ADDENDUM NO. 02
TO THE CONSTRUCTION DOCUMENTS BID PACKAGE

Client: Arrowhead Regional Medical Center
Project: Oncology-Ambulatory Clinic
SHA Project No.: 18242.100
Date: September 12, 2019

ARROWHEAD REGIONAL MEDICAL CENTER M.O.B. ONCOLOGY-AMBULATORY CLINIC

N2 CLINICAL ASSISTANT 018 SCALE: 3/8"=1'-0"

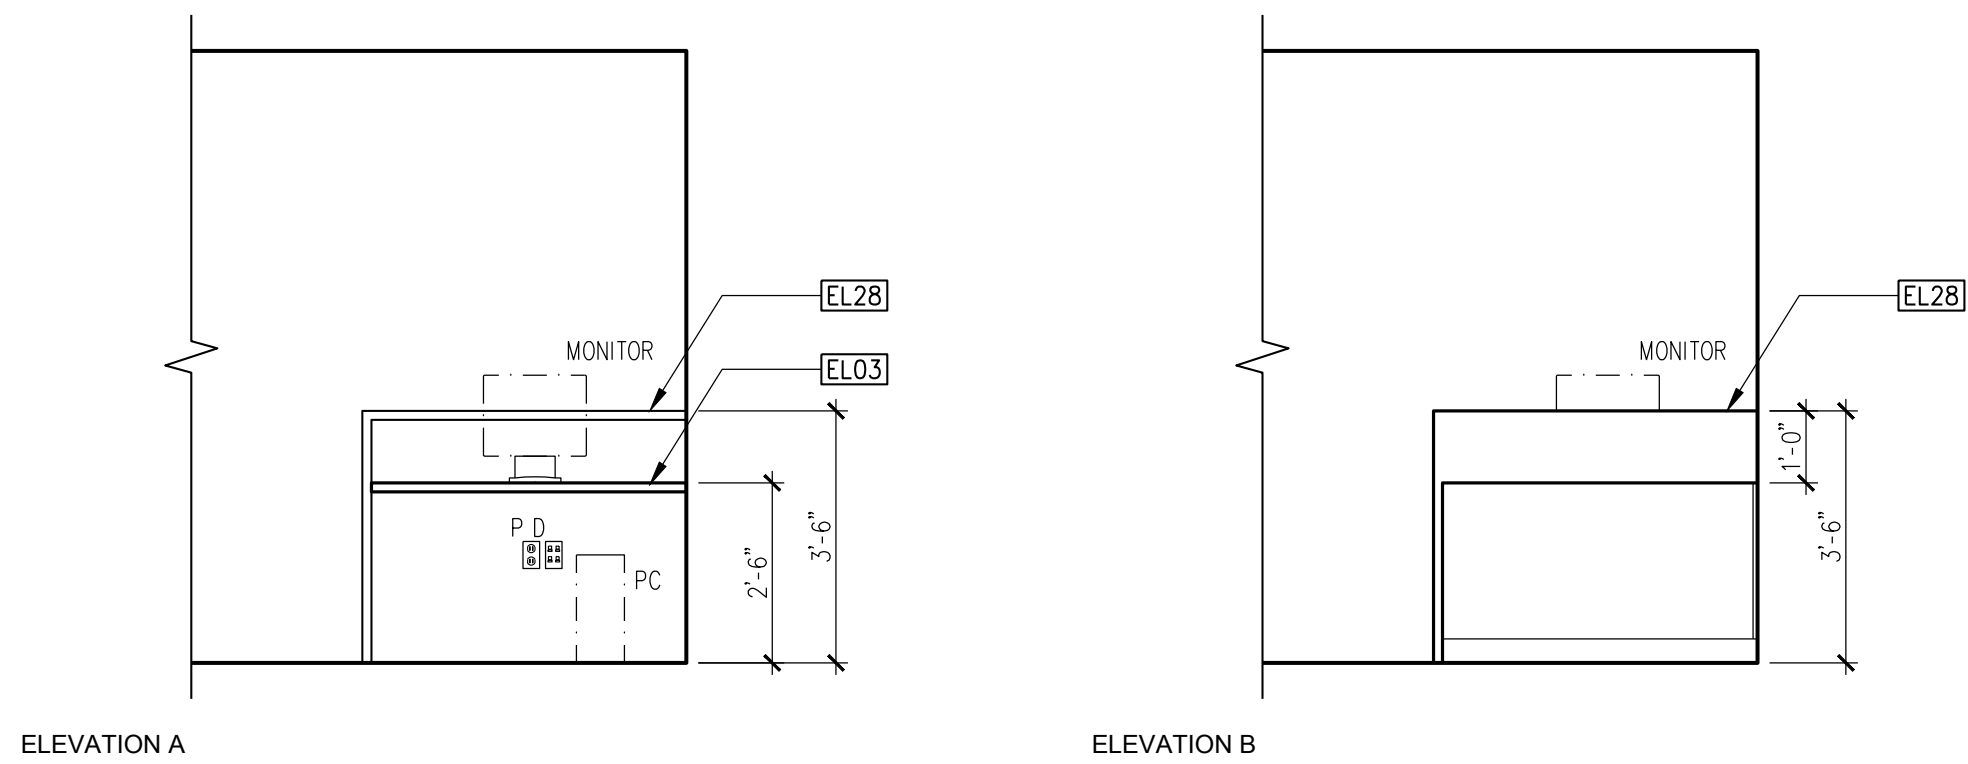
- A201** Clinical Assistant 018 Interior Elevation E added to sheet at N2/-.
Cabinet locks added to various elevations and Keynote EL30 added to Keynotes.
General Note prohibiting cabinet locks at accessible sink aprons added to General Notes.
Detail callout revised to reference correct detail.

N2 PHYSICIANS OFFICE 037A, B, C TYP.

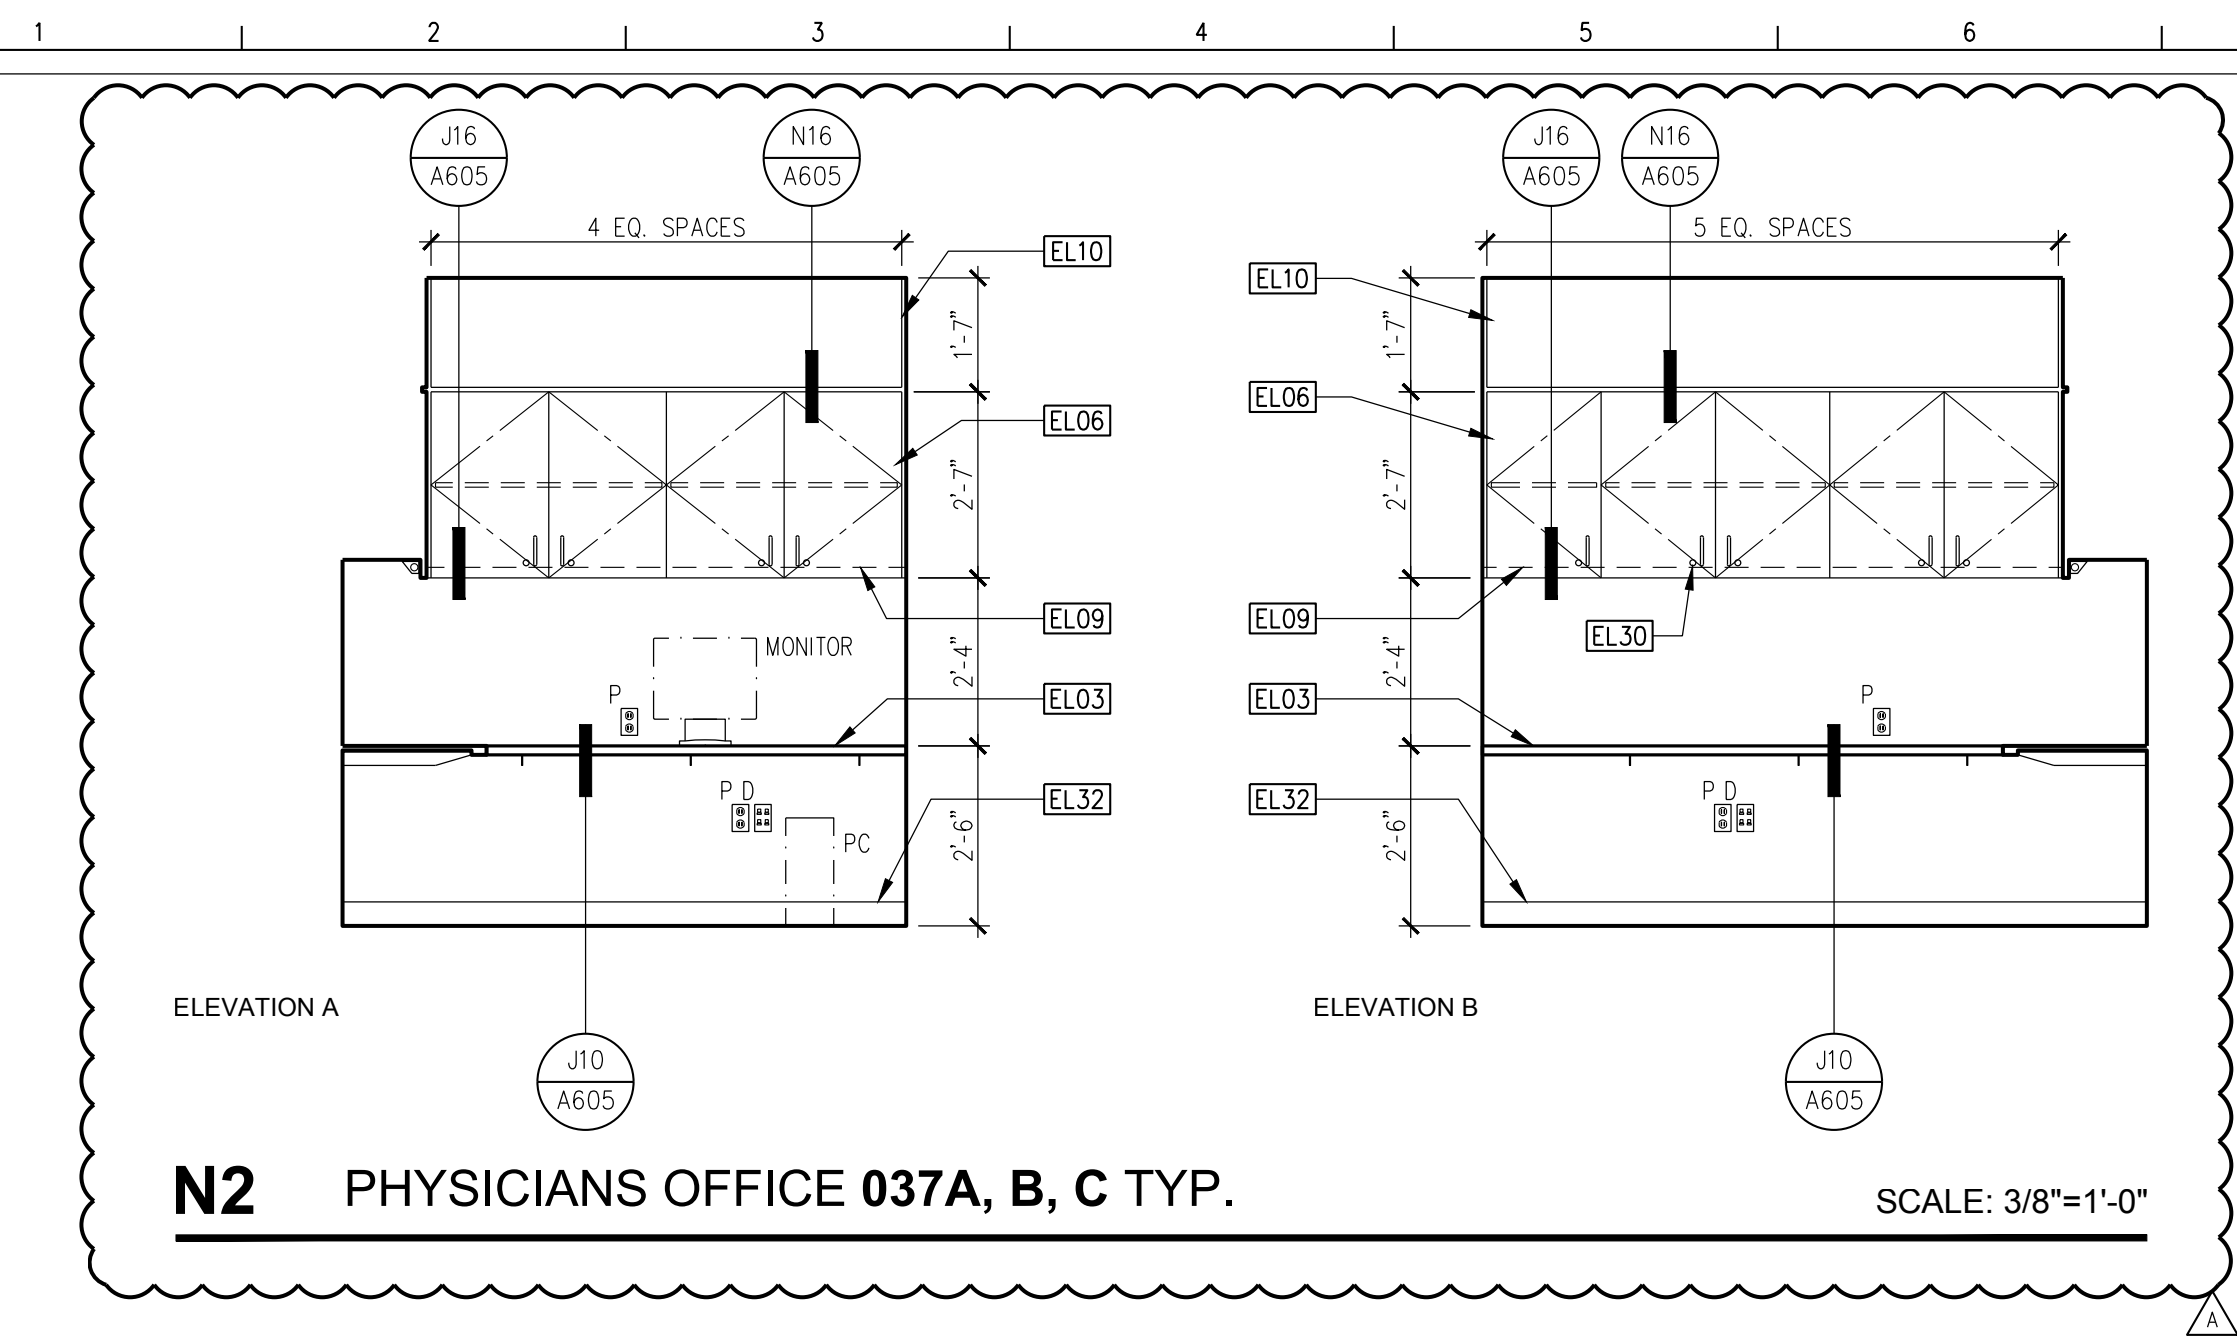
- A202** Physician's Office 037A, B, C Interior Elevations A & B added to sheet at N2/-.
Cabinet locks added to various elevations and Keynote EL30 added to Keynotes.
General Note prohibiting cabinet locks at accessible sink aprons added to General Notes.
Elevation E6 revised to show padlock hasp at plastic laminate lockers.
Elevation J1 revised to match floor plan.
Various detail callouts revised to reference correct detail.
Elevation E2/- added to sheet.

A3 HVAC DEMOLITION PLAN

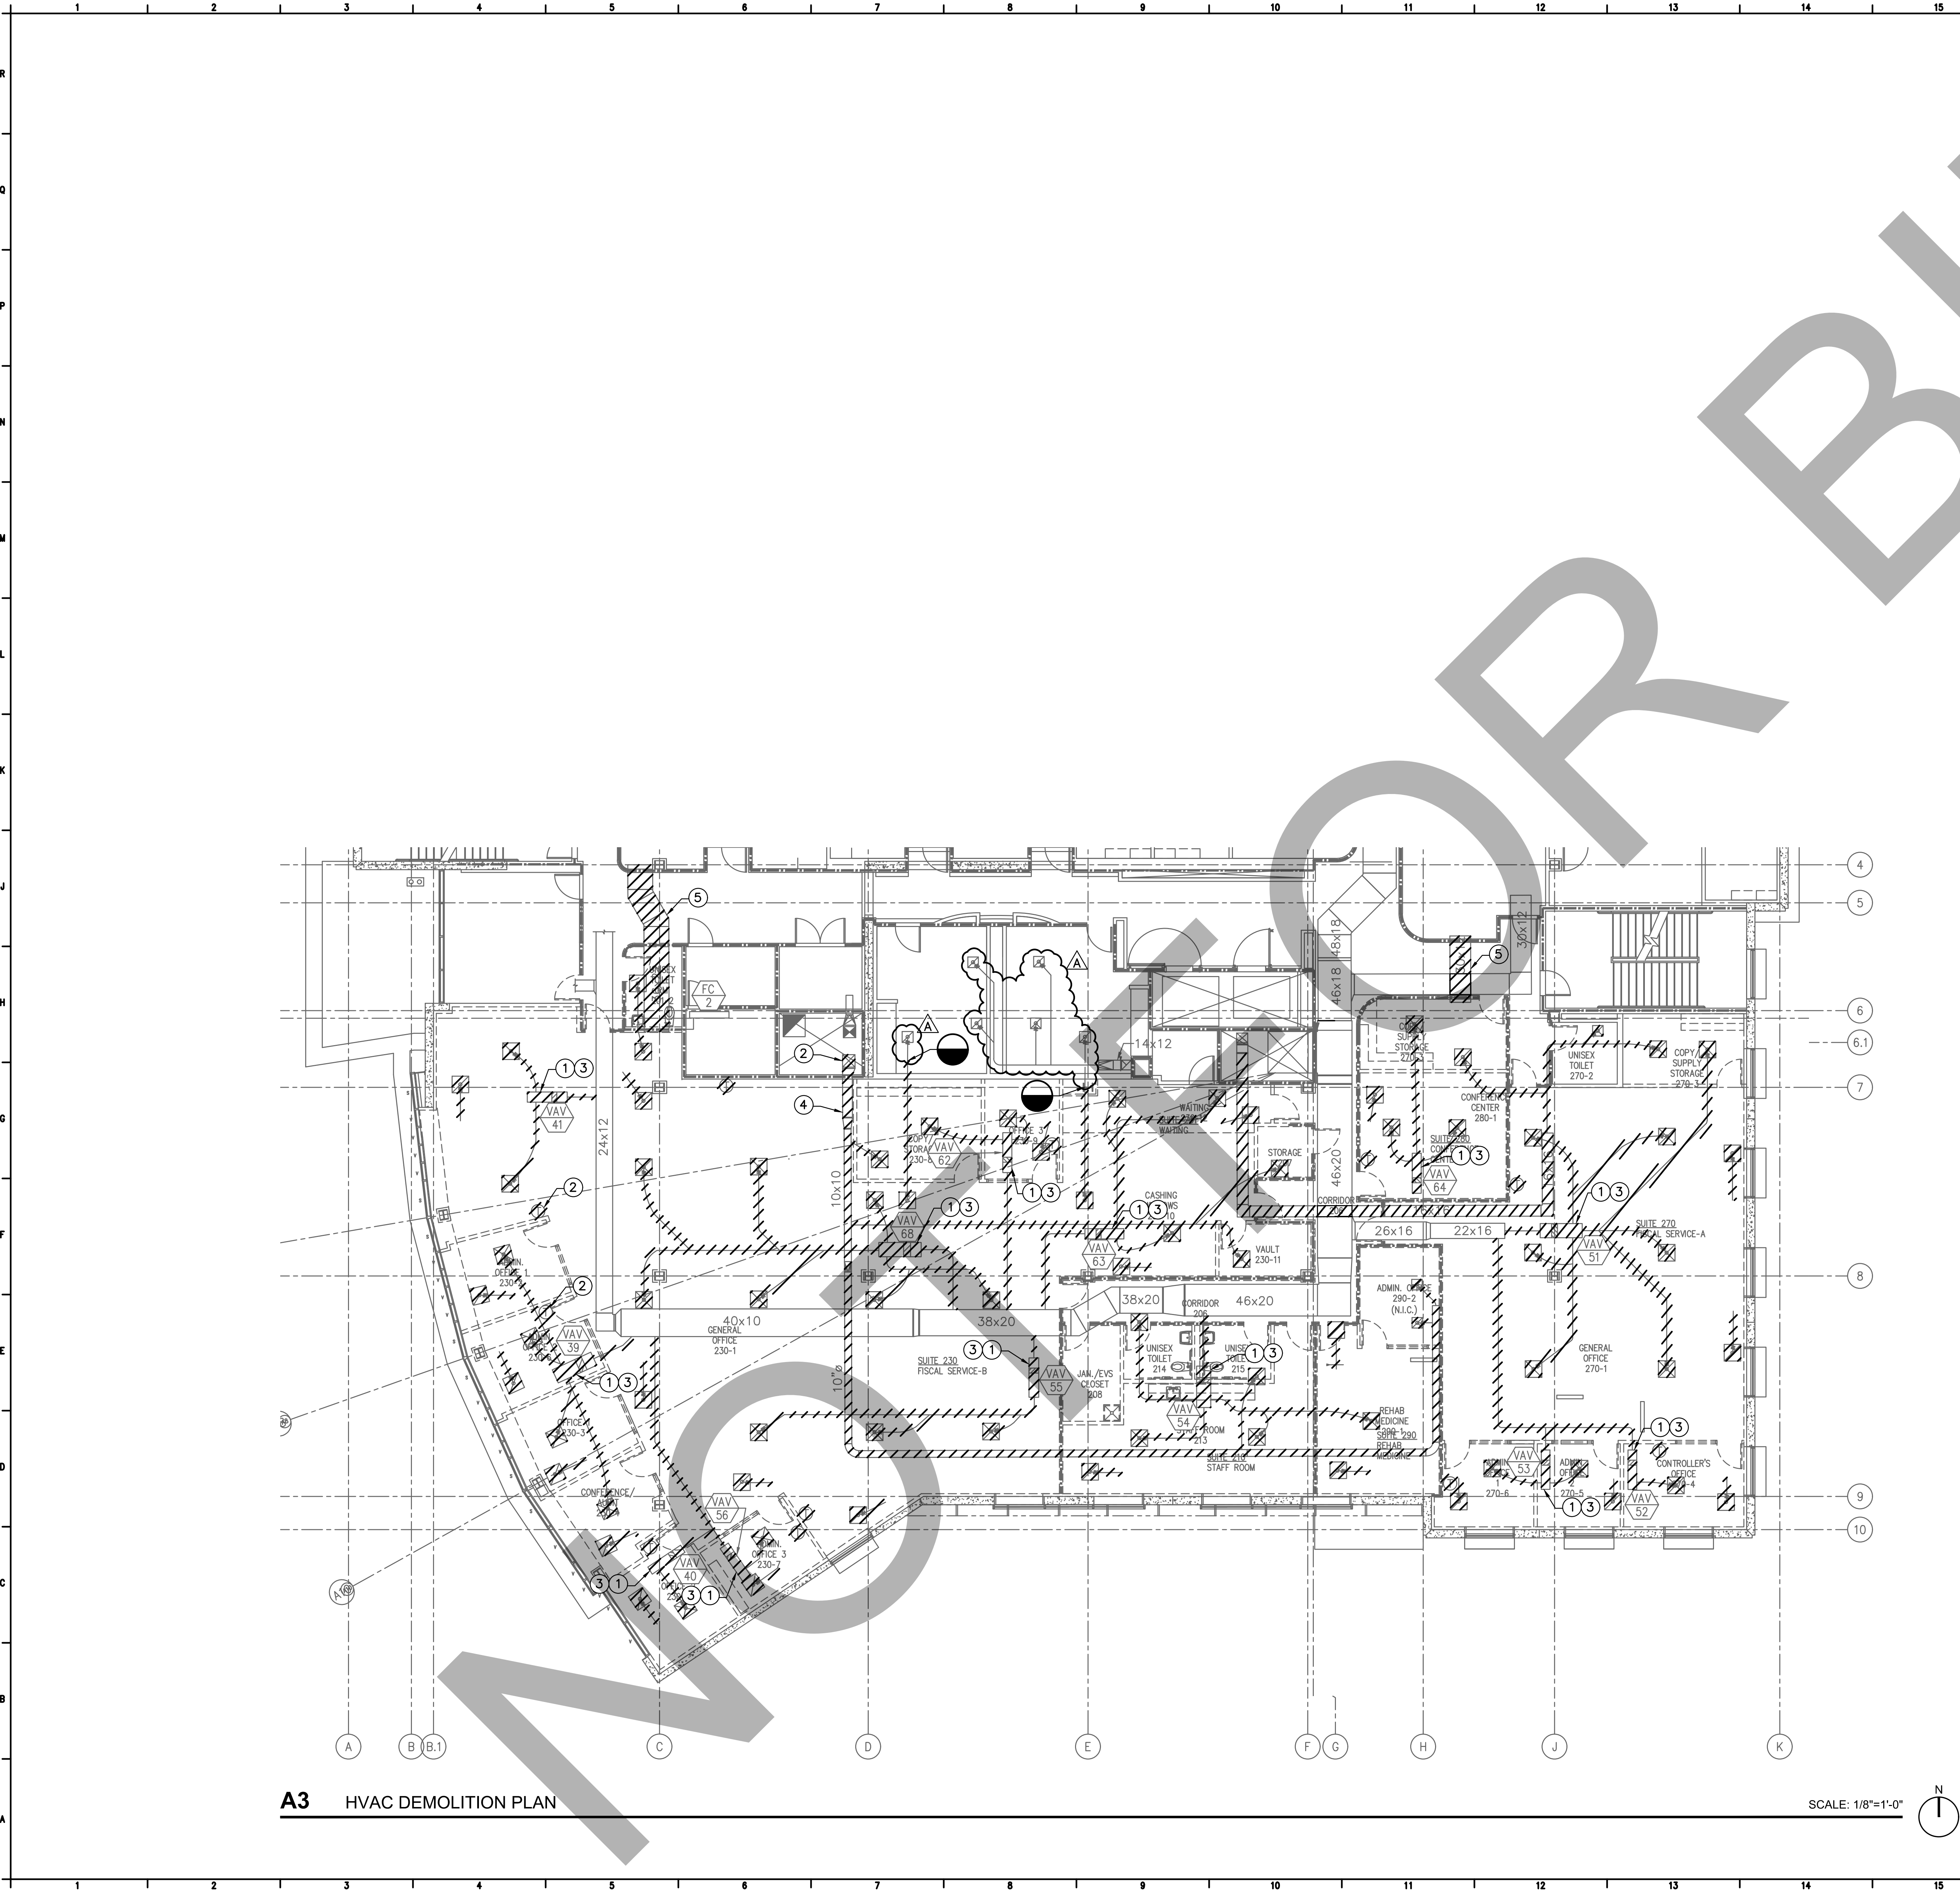
- A605** Revised detail number.
- M111** Revised demolition scope in the existing public restrooms.
- M122** Revised ductwork.
- M125** Added note to sheet regarding patching exterior finishes.
Added General Note #4 referencing framing details.
